PREVOST

WARRANTY BULLETIN

WB23-35

DATE:	March 2024	SECTION:	06 ELECTRICAL
EXPIRATION:	March 2026		
SUBJECT:	DPF HARNESS REPLACEMENT

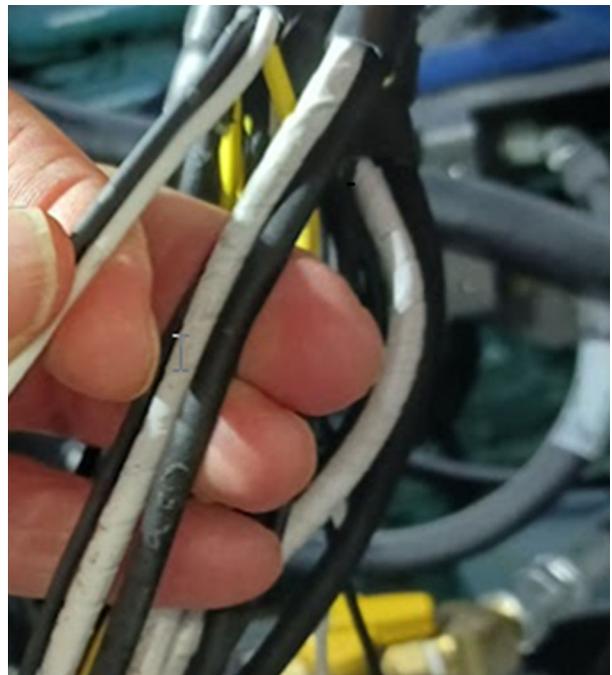
3. Remove one foot of the loom from connector B97.
4. Verified if you have wires with a splice see the picture.
 - If yes, go to the next step.
 - If no, reinstall the loom and secure the cable to complete the procedure.

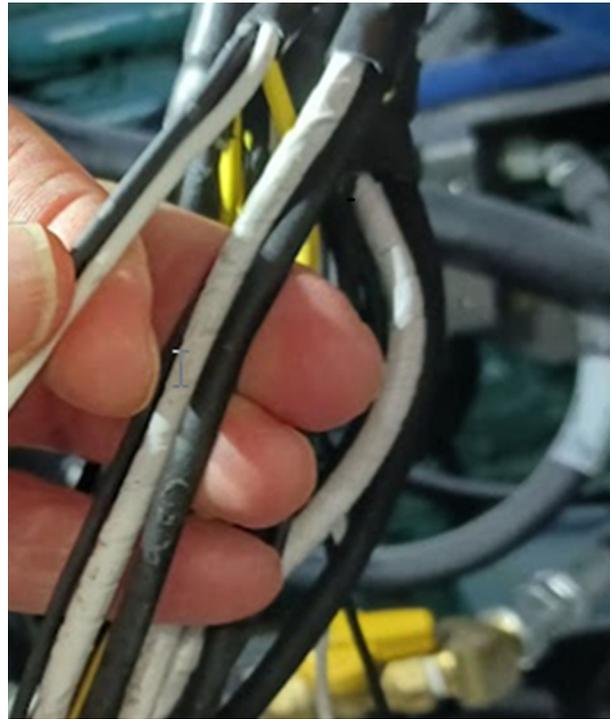
3. Remove one foot of the loom from connector B97.
4. Verify if you have wires with a splice see the picture.
 - If yes, go to the next step.
 - If no, reinstall the loom and secure the cable to complete the procedure.

HARNESS REPLACEMENT H3 MODEL

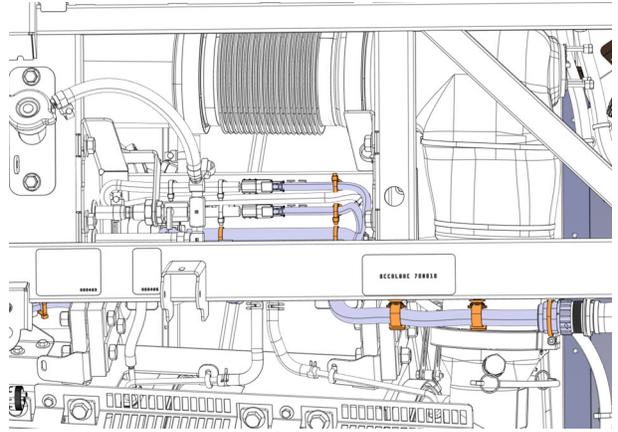
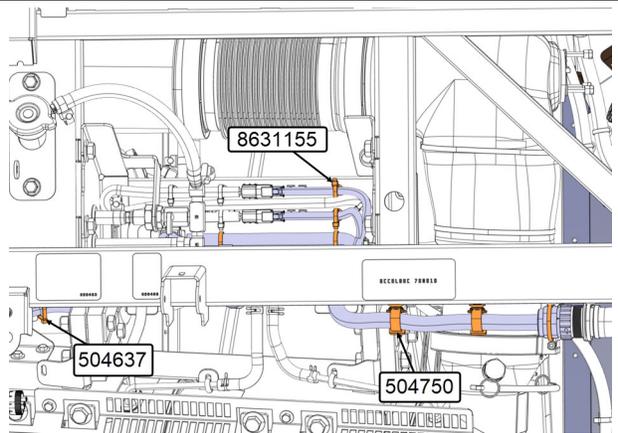
5. Cut all cable ties that secure the DPF harness.
6. Unplug the harness.

7. Install the new DPF harness 060746.
8. Secure the harness using cable ties 8631155 (6x), 504637 (6x) and 504750 (2x)

HARNESS REPLACEMENT X3 MODEL

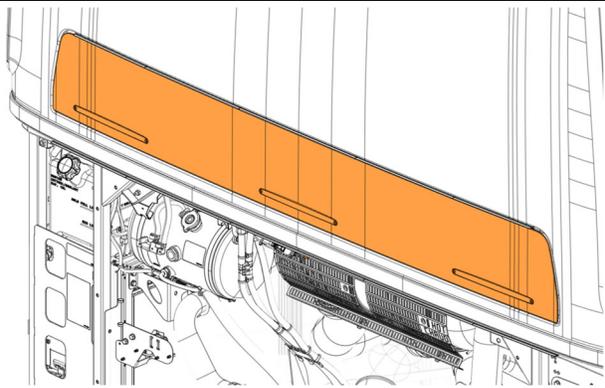
5. Cut all cable ties that secure the DPF harness.
6. Unplug the harness.

7. Install the new DPF harness 060089.
8. Secure the harness using cable ties 8631155 (6x), 504637 (6x) and 504750 (3x).
